Access Compliance Report Public Rights-of-Way (Curb Ramps)

Main Street: ROOSEVELT_AVE Cross Street: BEACH_BLVD Location: SE

ADA ID: RPRK211001145621 Ramp Type: Type 1 - Perpendicular Diagonal Initial Pass/Fail: Pass Overall Compliance: No Severity Score: 20

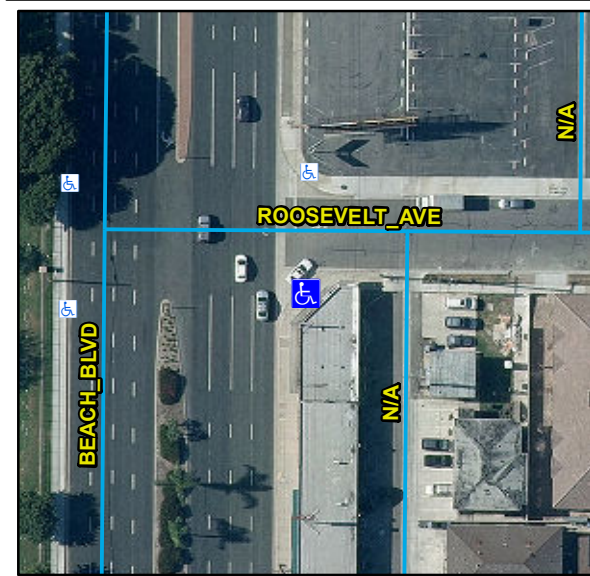
OC Std/PROW:
R304.2.1, R304.2.2-Perp, R304.3.2-Para, R304.5.3, R305, STD 1115

Possible Solutions:
Remove & Replace Curb Ramp With Two New Directional Ramps or Equivalent.
